<b>Notice of Allowability</b>	<b>Application No.</b>	<b>Applicant(s)</b>	
	10/816,583	MORI ET AL.	
	<b>Examiner</b>	<b>Art Unit</b>	
	Pia F. Tibbits	2838

### **DETAILED ACTION**

Fig. 1

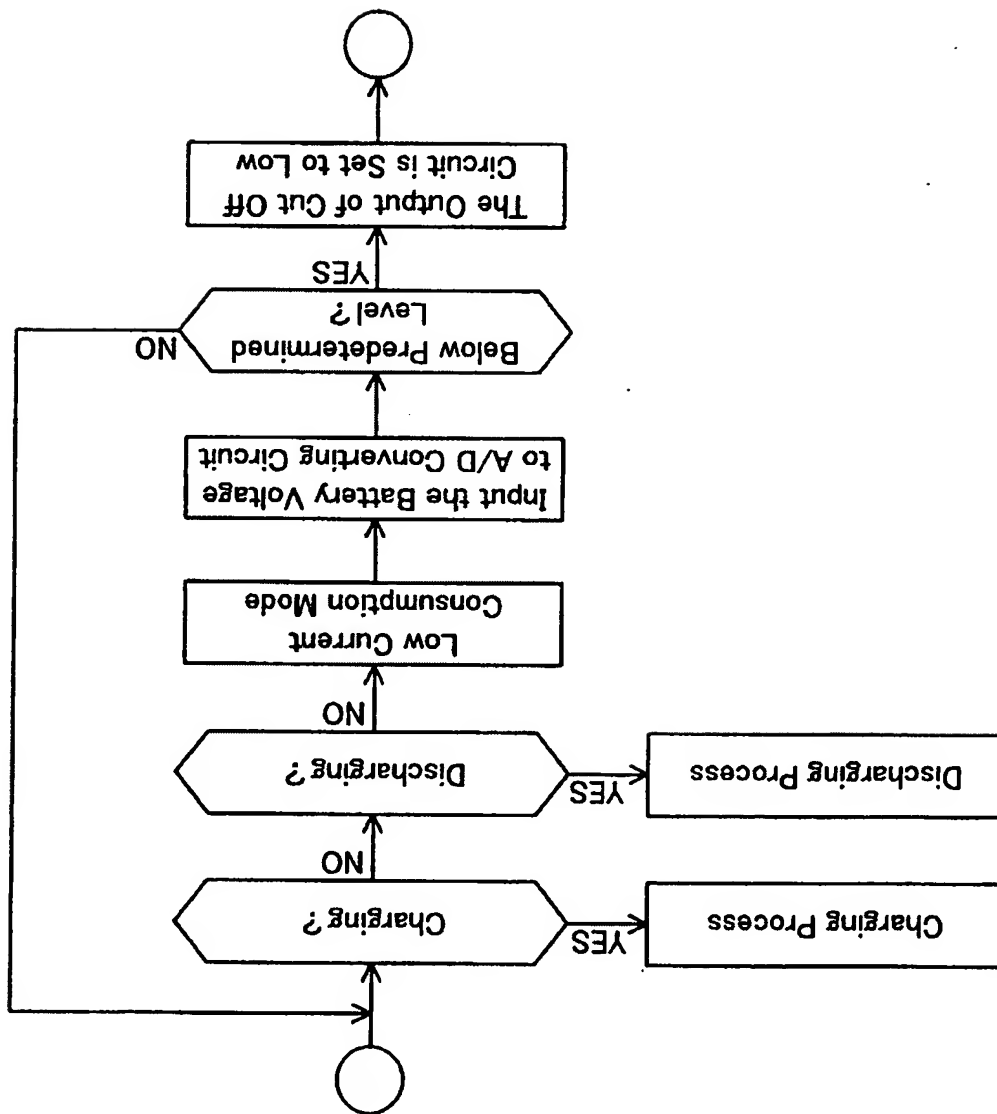
Newly submitted figures 1-4 are not in compliance with 37 CFR 1.121(d) since 1) the newly added limitation "LED display" is not shown, and 2) any amended replacement drawing sheet should include all of the figures appearing on the immediate prior version of the sheet, even if only one figure is being amended. The figure or figure number of an amended drawing should not be labeled as "amended." If a drawing figure is to be canceled, the appropriate figure must be removed from the replacement sheet, and where necessary, the remaining figures must be renumbered and appropriate changes made to the brief description of the several views of the drawings for consistency. Additional replacement sheets may be necessary to show the renumbering of the remaining figures. Each drawing sheet submitted after the filing date of an application must be labeled in the top margin as either "Replacement Sheet" or "New Sheet" pursuant to 37 CFR 1.121(d).

Not Approved  
1/28/06

Formal drawings to be submitted.
